PREPARED B. Williams		DART AEROSPACE LTD VICTORIA INTERNATIONAL AIRPORT, CANADA	
CHECKED <i>[Signature]</i>	APPROVED <i>[Signature]</i>	DEO 9031	REV 4 SHEET 1 OF 2
DATE June 29, 1995		TITLE BELL 206 BELLY POD LATCH

**ENGINEERING ORDER
REGARDING DRAWING D206-606
REPLACEMENT OF EXISTING LATCHING MECHANISM**

VIEW SHOWING INSIDE OF DOOR

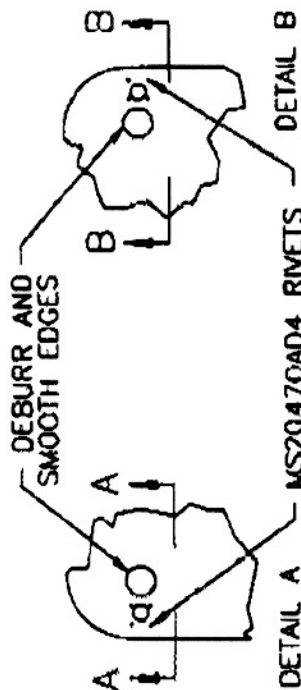
REMOVE EXISTING INTERNAL
LATCHING MECHANISM
LEAVE HANDLE

EXISTING COVER CHANNEL
REPLACE AFTER INSTALLATION

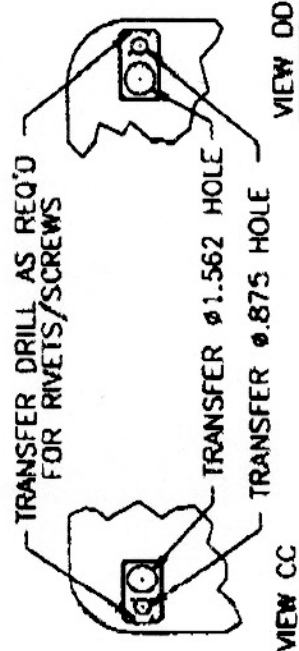
MS2047QAD4 RIVETS
(4 PER LATCH) OR—
AN526--632R7 SCREW(4)
MS21042L06 NUT(4)
AN960JD6 WASHER (4)
TRANSFER DRILL AS REQ'D

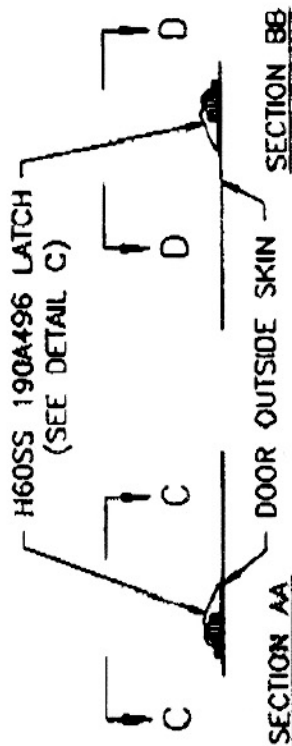
D2147 STRIKER PLATE (TYP)
USE PACKERS TO ADJUST CLEARANCE

D2145 DOUBLER
BOND TO INSIDE OF
DOOR WITH METALSET A4
